GW - 24

**GENERAL  
CORRESPONDENCE**

AVALON PLANT

WASTE WATER DISCHARGE PLAN

GAS COMPANY OF NEW MEXICO	
NATURAL GAS FLOW AVALON PLANT DRAWING A	REVISED
	SEPT 1964
Drawn By: K. TIDWELL Date: April, 1962

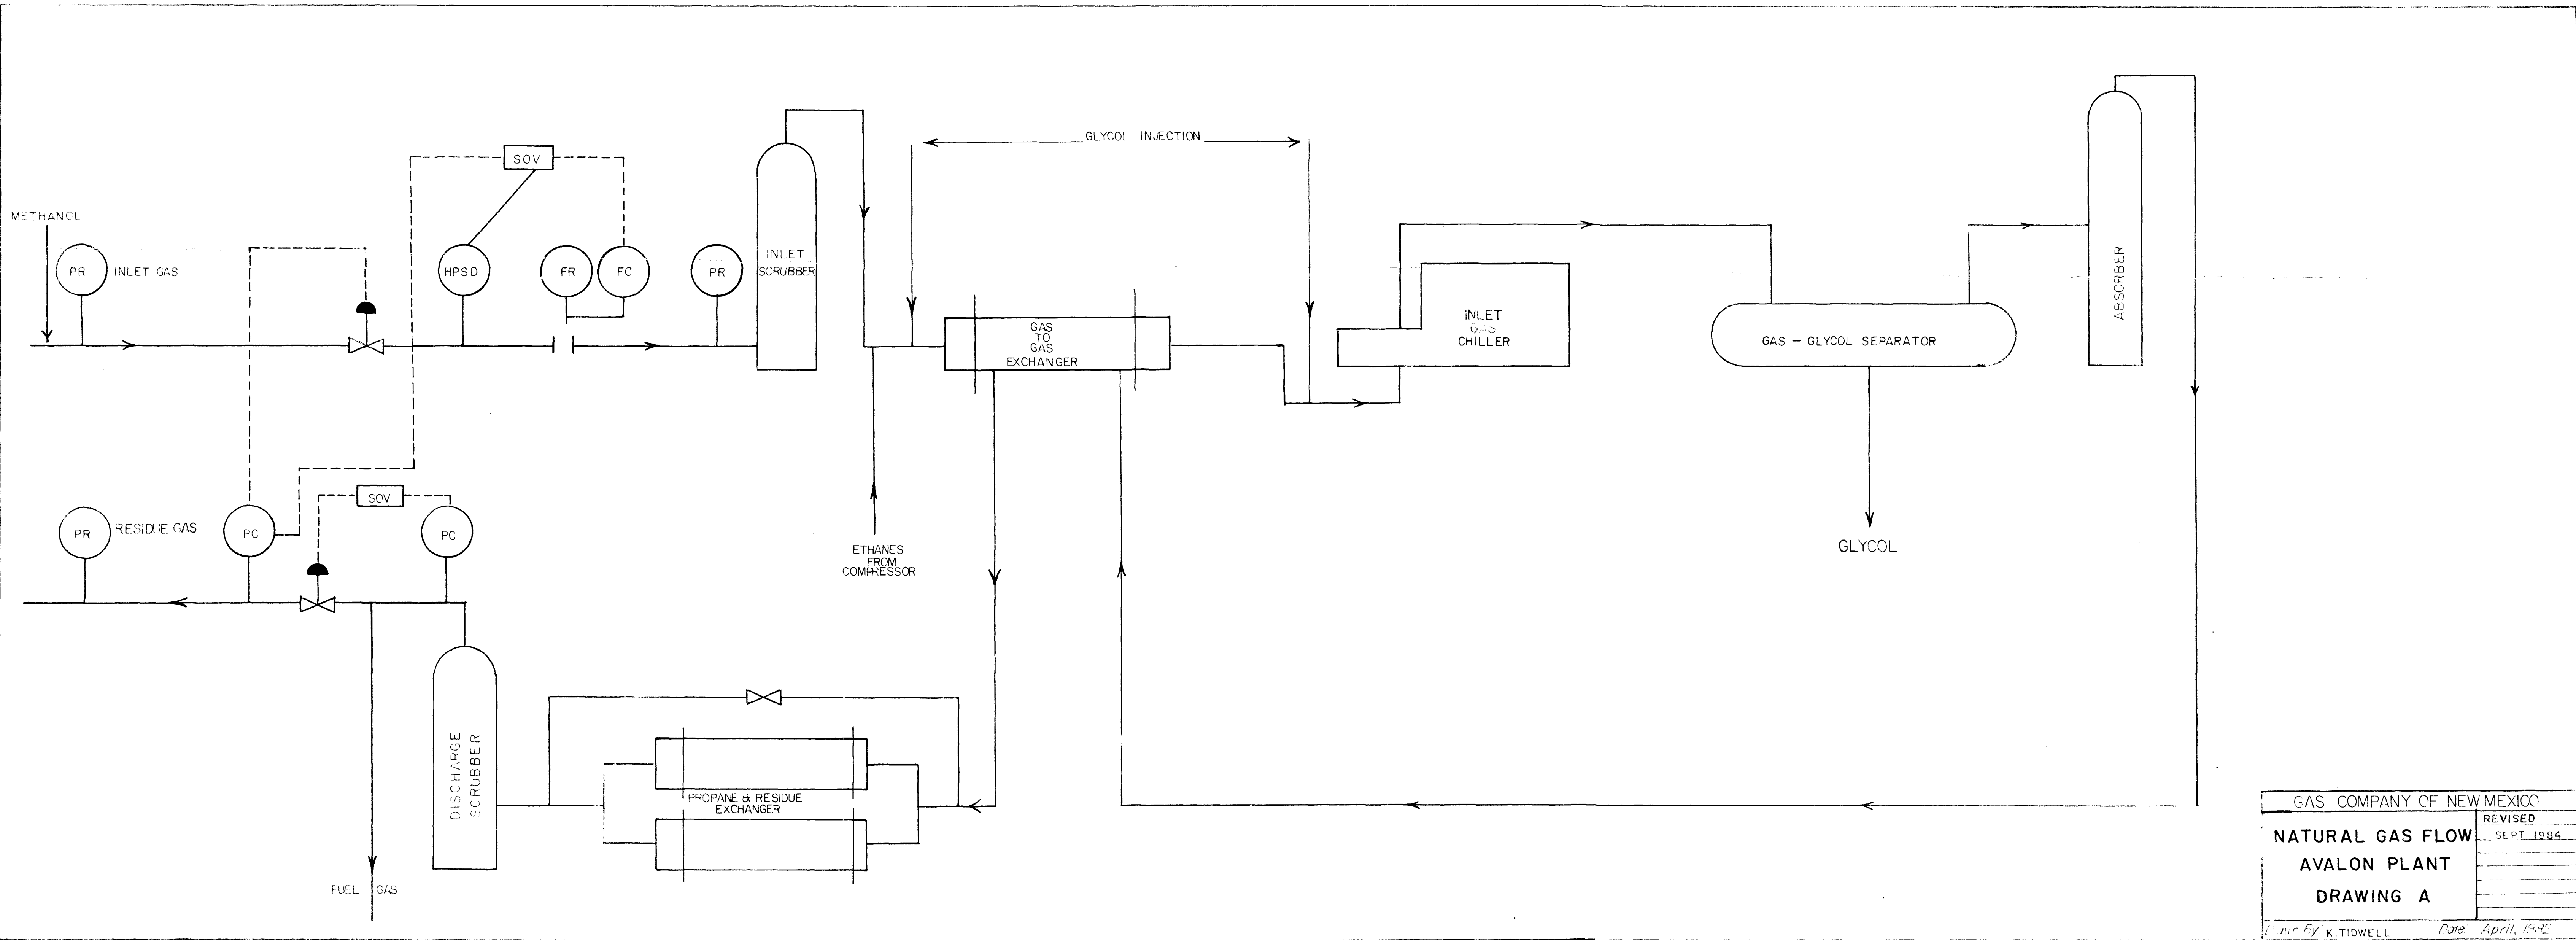
1. As referenced in Drawing A of your discharge plan, methanol is introduced to the gas stream. At what rate and concentration is it introduced? Does it remain in the product or is it regenerated or disposed of? If disposed of, to what effluent stream is it delivered to? How is the methanol supply stored?
2. Drawing C indicates that Corcheck is injected in the rich oil line upon exiting the rich oil filter. What is the injection rate? Is it separated from the stream later on and disposed of? If so, what effluent stream is it disposed to? Provide a chemical description or safety sheet (if available) for Corcheck.
3. How is the caustic supply stored?
4. The discharge scrubber in the propane flow

2. Injection rate is one quart per day. It is not separated from the stream. Description sheet attached for Corchek 1686.
3. The caustic (NaOH) is stored in an above ground steel tank. Capacity is 210 barrel (8820 gallons).

GAS COMPANY OF NEW MEXICO	
AVALON PLANT PLOT PLAN	REVISED
	SEPT, 1984
DRAWN BY K. TIDWELL	OCT, 1981

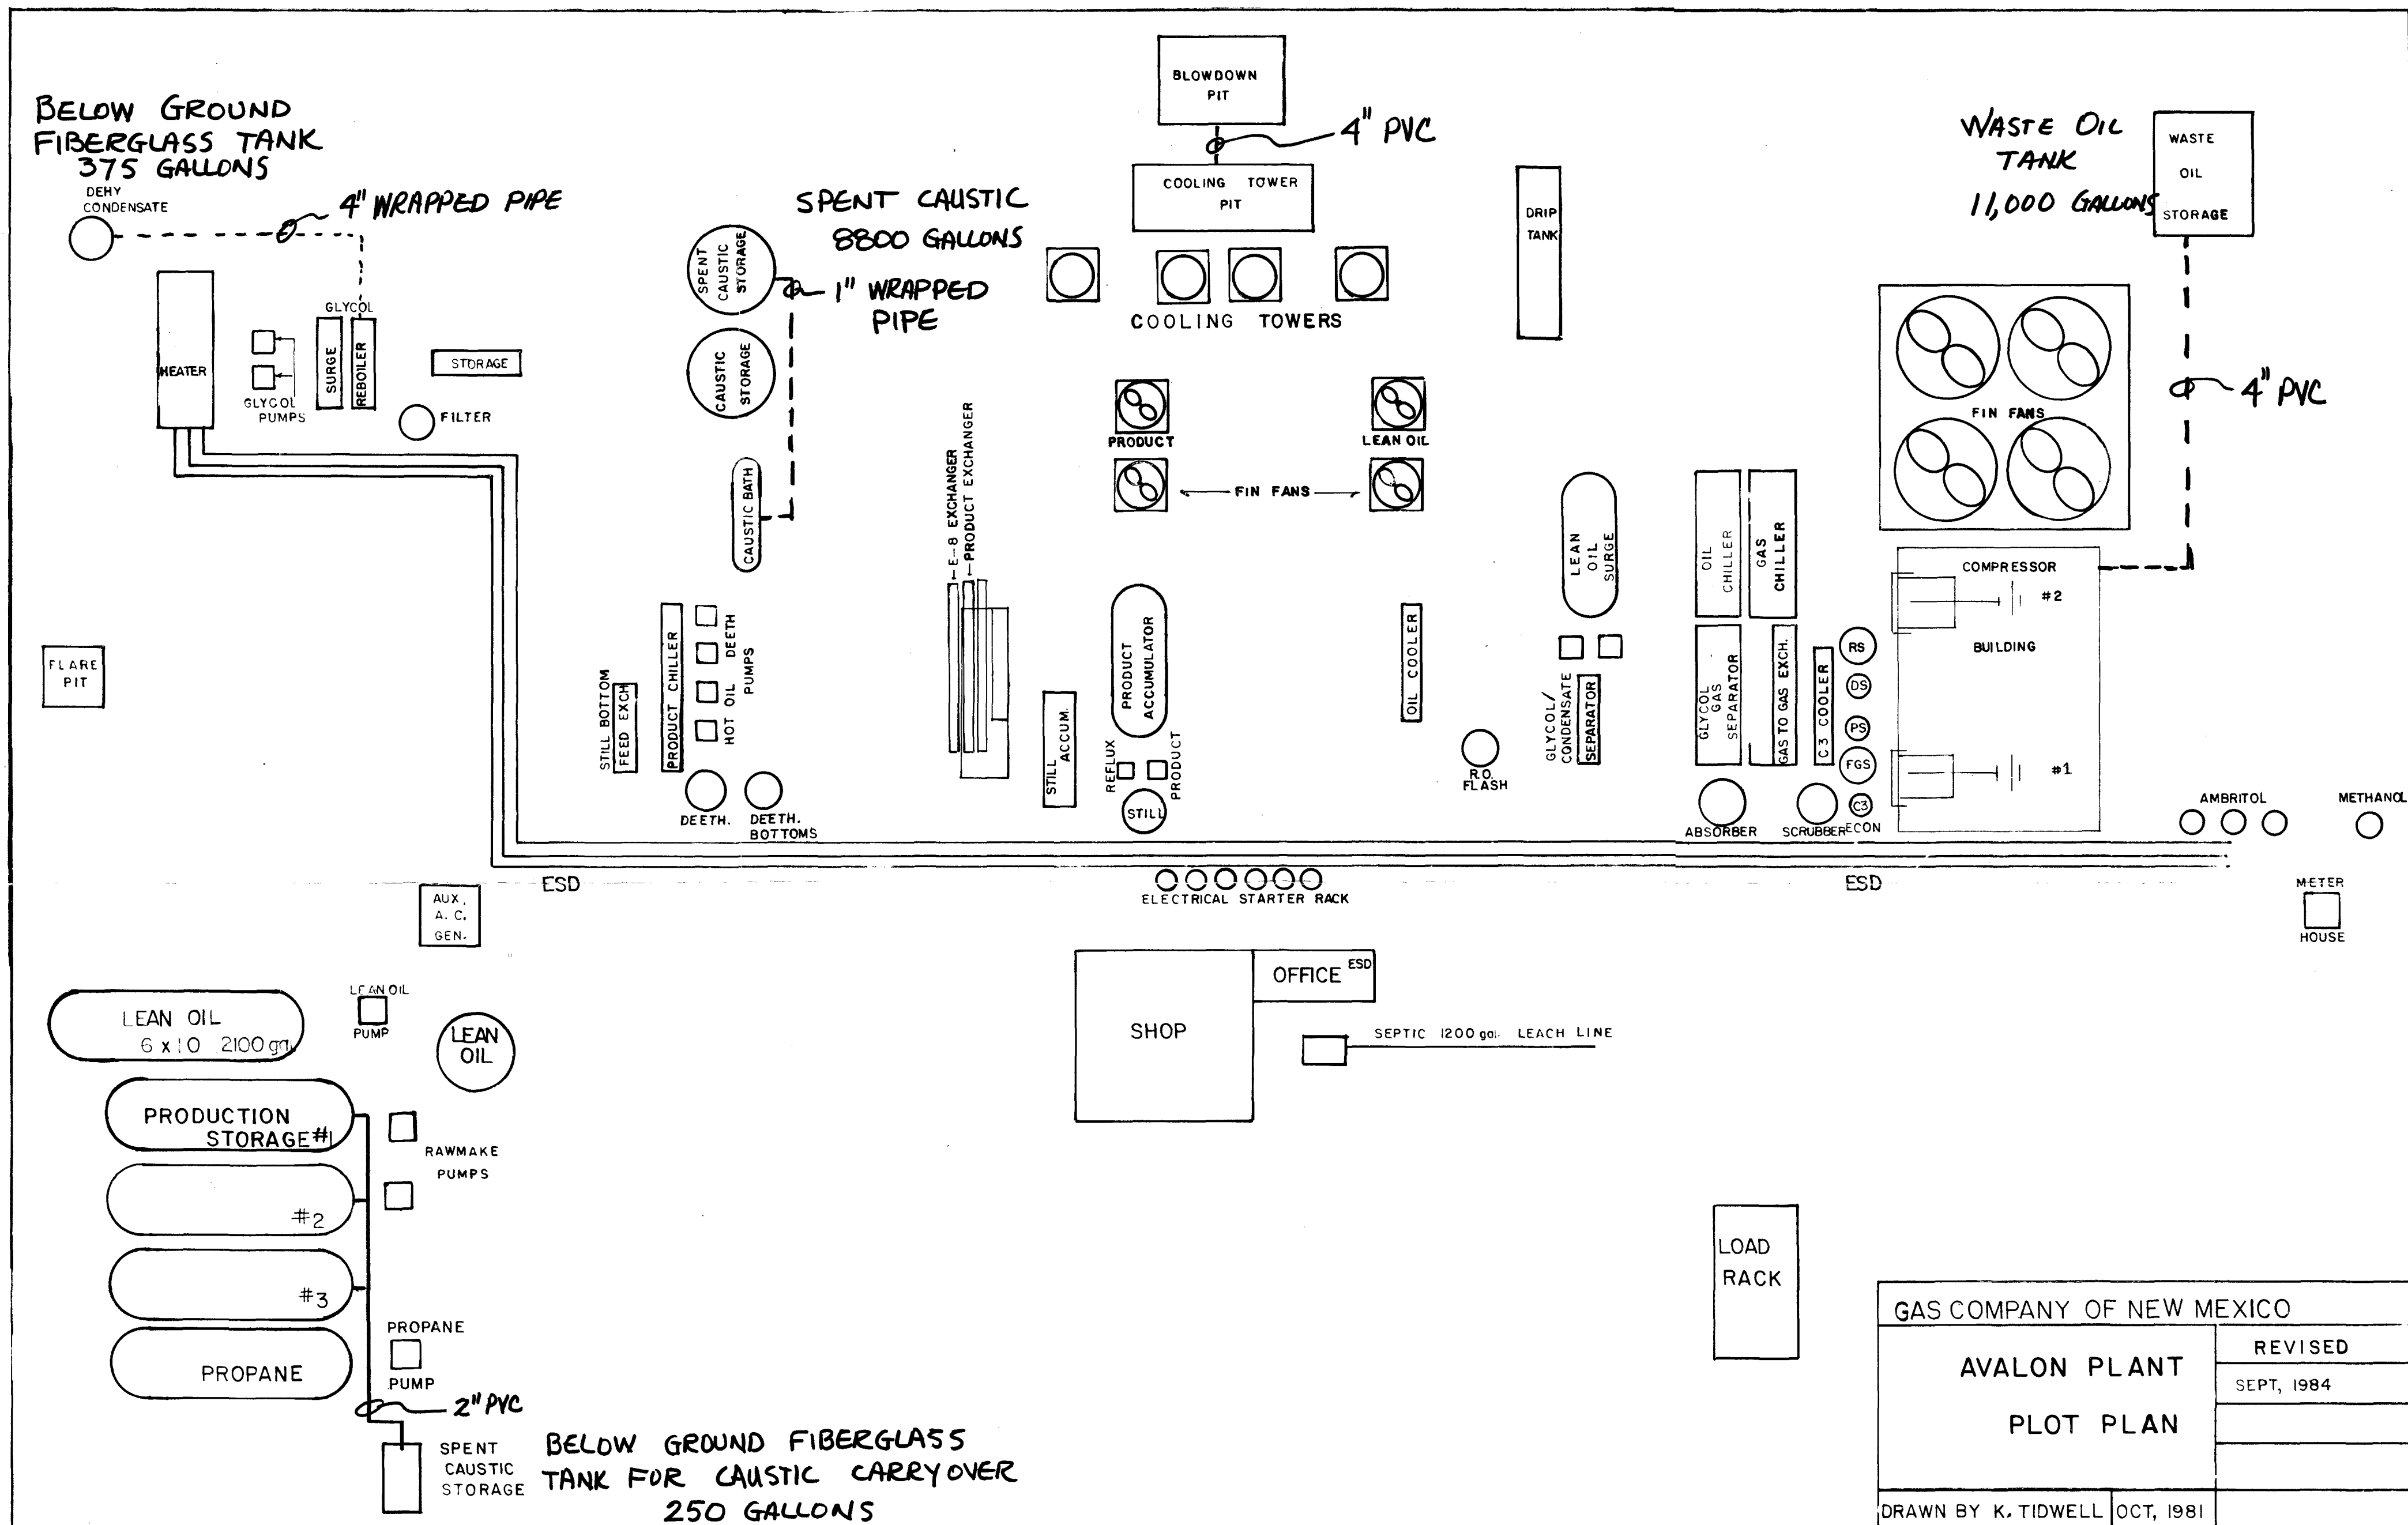
10. What is used for pH control in the glycol reboiler? In what quantities and where is this chemical stored?
11. Your plot plan shows both a cooling tower pit and a blowdown pit. The blowdown pit is described as being unlined. Provide the dimensions of both pits and liner information for the cooling tower pit. Are there any monitor wells? Were chromates ever used as treatment chemicals in the cooling towers?
